APPEND THE FOLLOWING DOCUMENTS WHEN CHANGING THIS DOCUMENT:		DRAWING CONTENT:		TITLE SCHEMATIC DIAGRAM SF1000 SERIES		<div> 2900 SPAFFORD ST. DAVIS, CA 95616 530 - 757 - 4616</div>	
		DRAWN BY: (INITIAL RELEASE) D.MURAVEZ	14FEB01				
		REVISED BY: K.SCHALLER	09/05/01				
APPROVALS: INITIAL RELEASE							
		PROJECT ENGINEER:		SIZE B	DWG NO. 090-0123		
		ENGINEERING MANAGER:					
		SIGNATURES	DATE	SCALE	NONE	RELEASE DATE	SHEET 1 OF 1

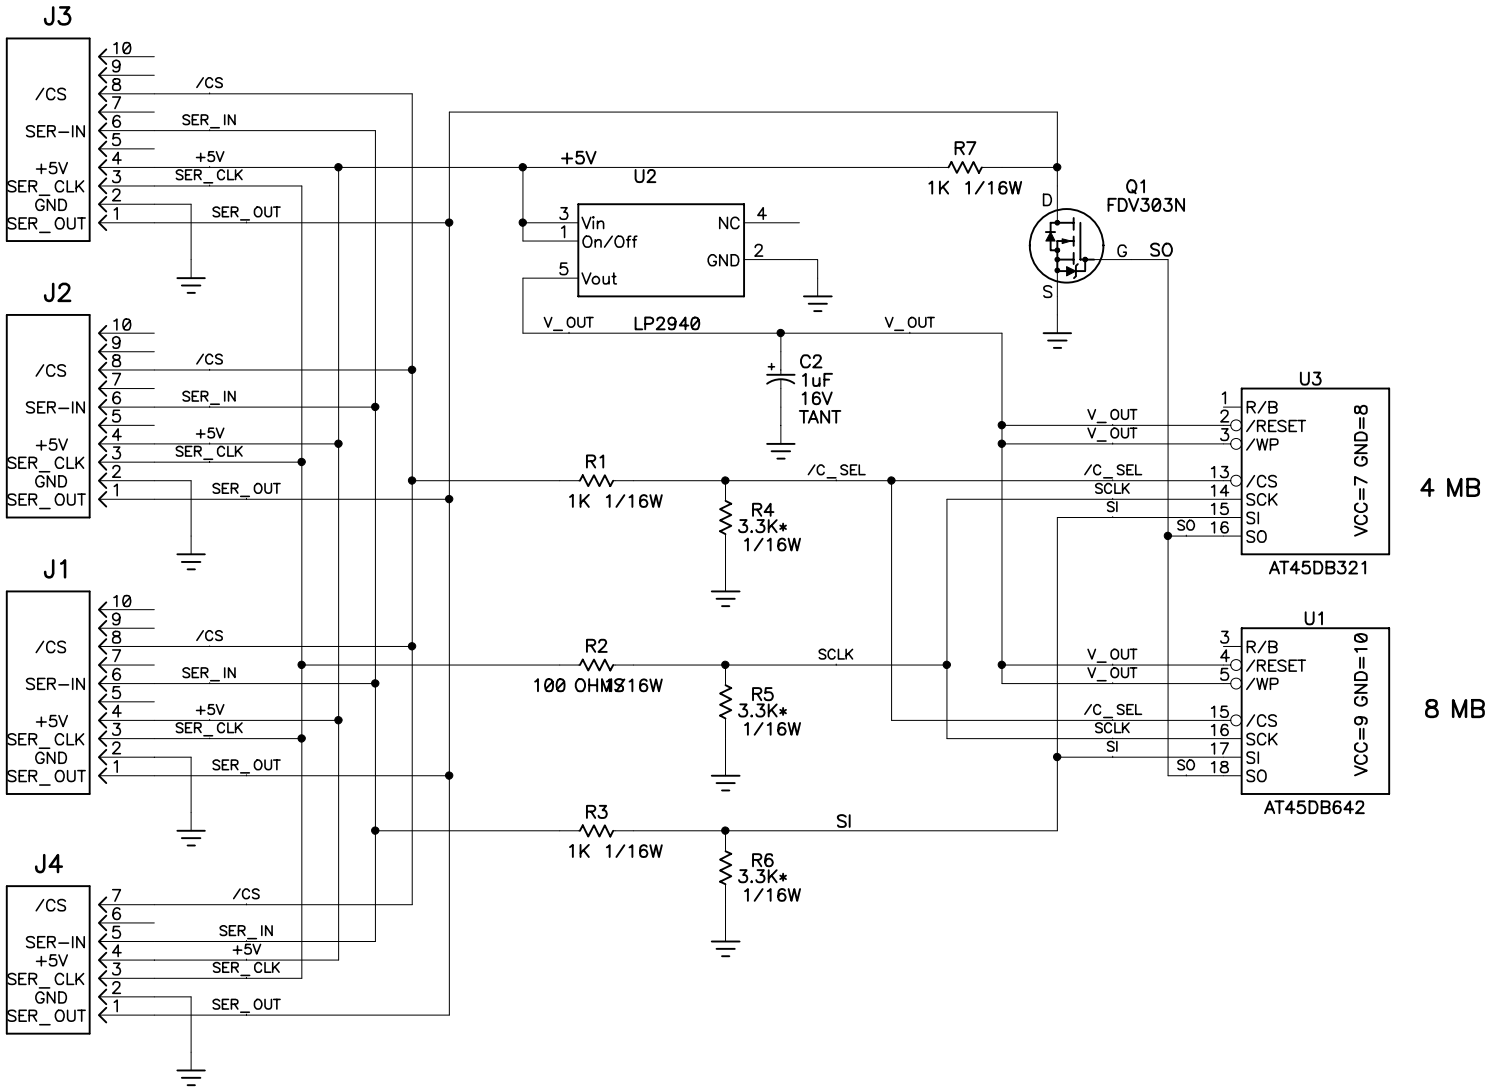
REVISION HISTORY				REVISION APPROVAL			
REV	ECO	DESCRIPTION		PROJECT ENGINEER	APPROVAL DATE	DOCUMENT CONTROL	APPROVAL DATE
A	E11620	INITIAL RELEASE		XT	8/7/01	KIS	8/7/01
B	E11652	CHANGE VALUE OF R2 FROM 1K TO 100 OHMS.
